REVISION	BY	DATE
CONDUIT AND LIGHTING REMOVED FROM CONTRACT	TFD	11/05/13

PROJECT NAME: **RUTLAND CITY**
PROJECT NUMBER: **STP 019-3(57)**
FILE NAME: ...rut.light.dgn
PROJECT LEADER: GAE
DESIGNED BY: TFD
LIGHTING & ELECTRICAL PLAN LE-03

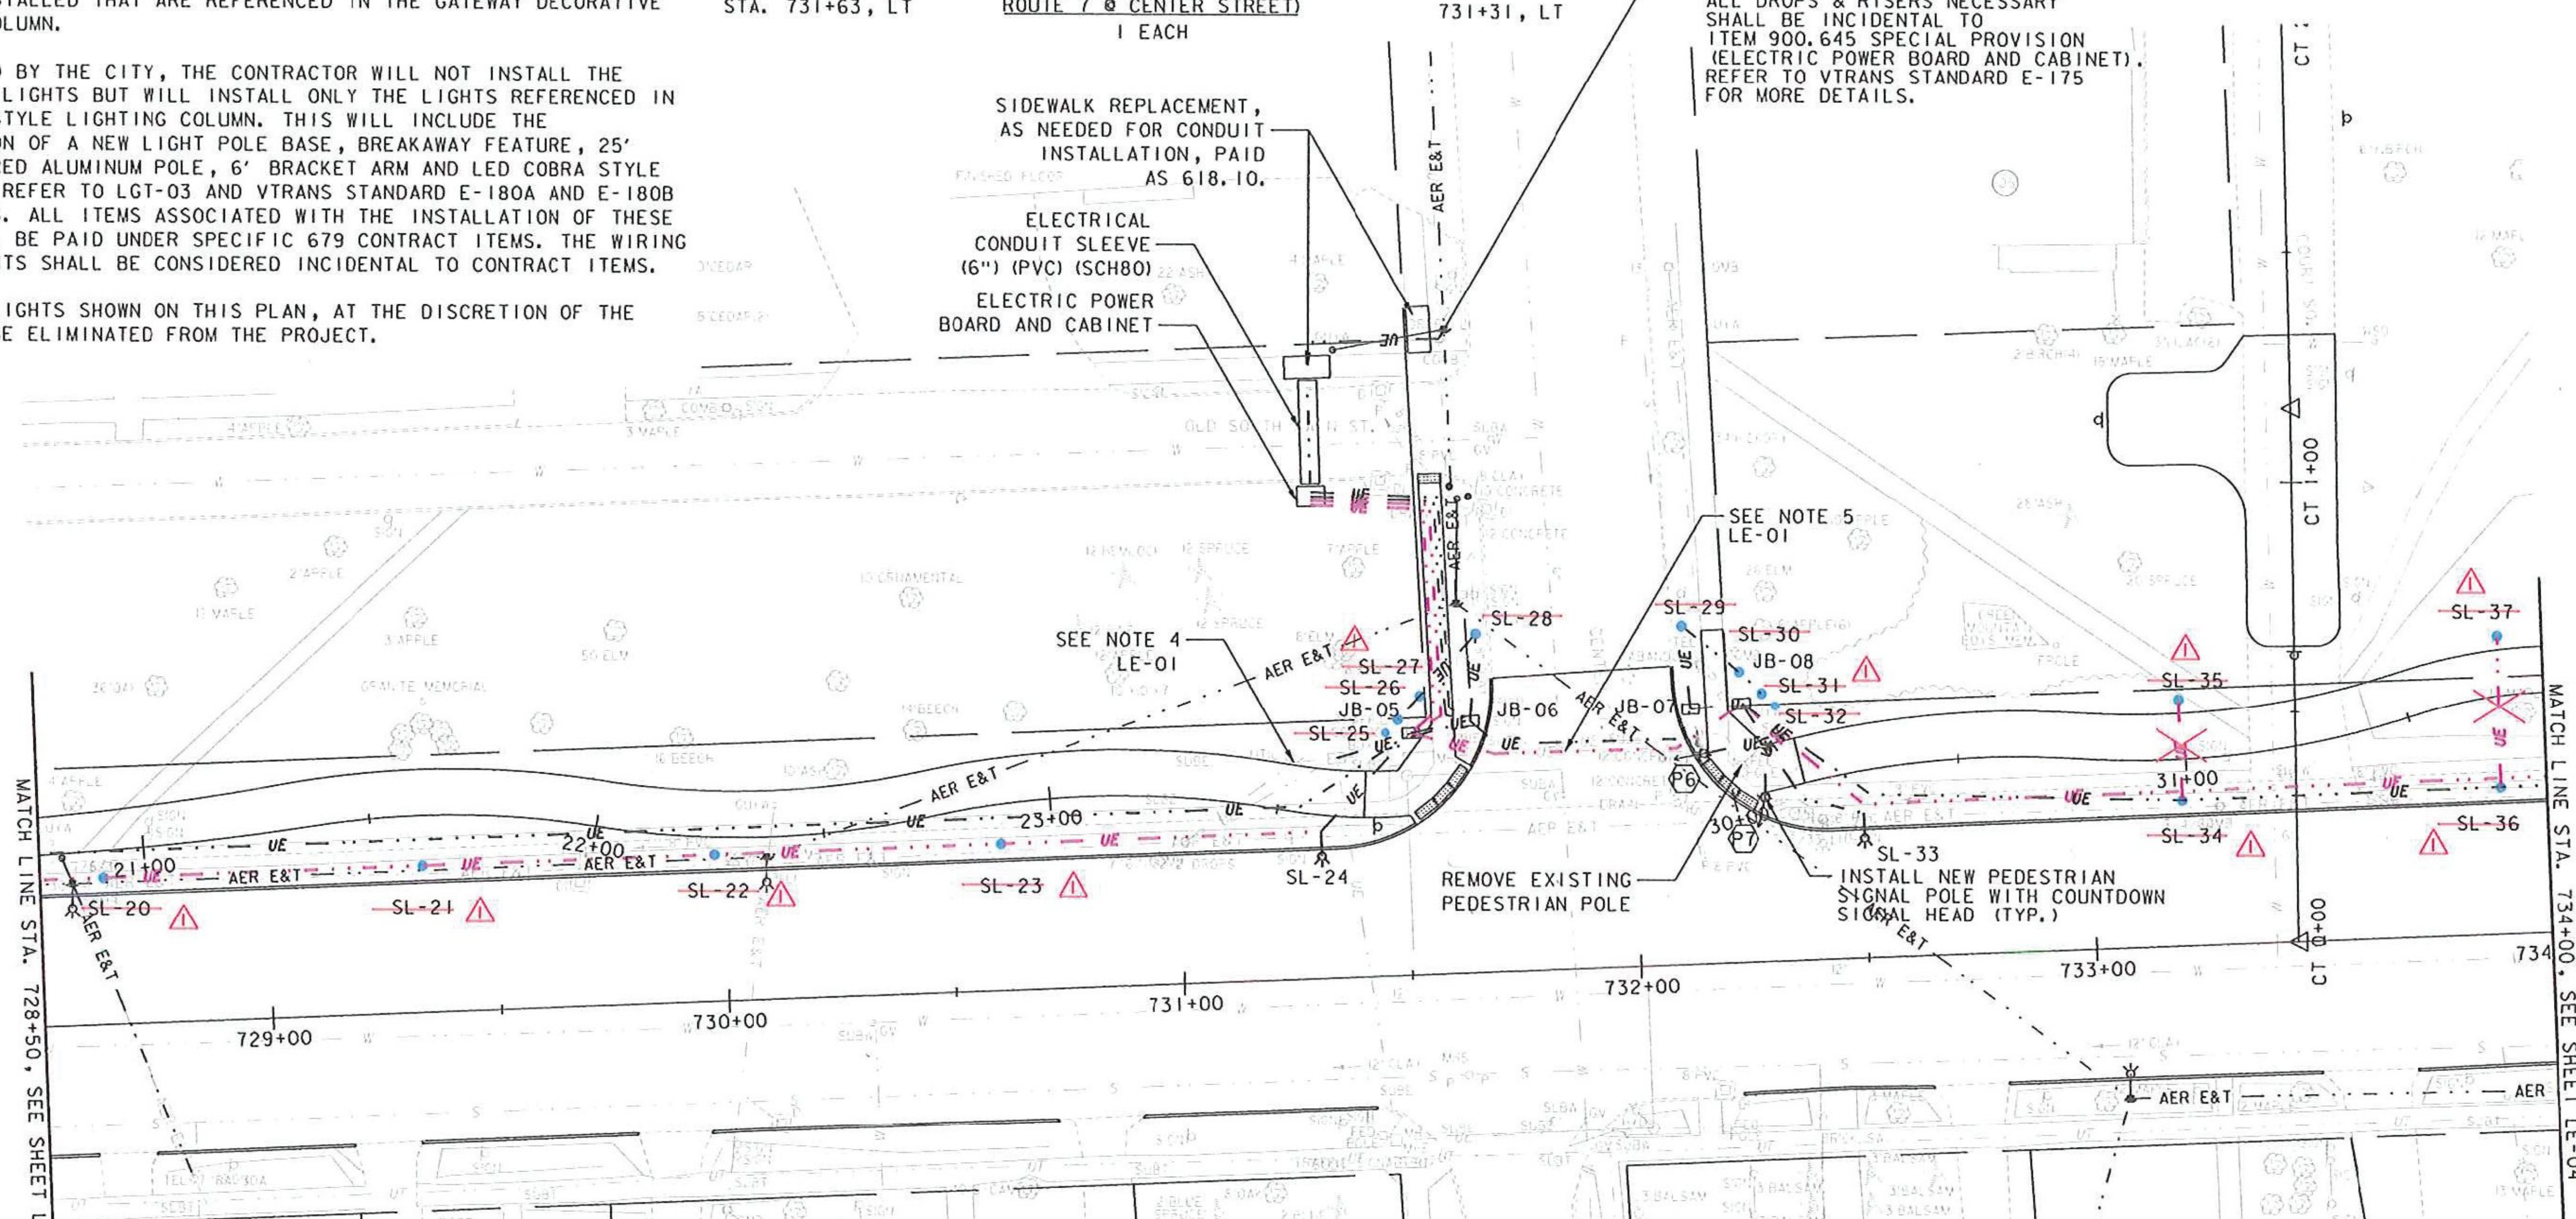
ALL OTHER LIGHTS SHOWN ON THIS PLAN, AT THE DISCRETION OF THE CITY, MAY BE ELIMINATED FROM THE PROJECT.
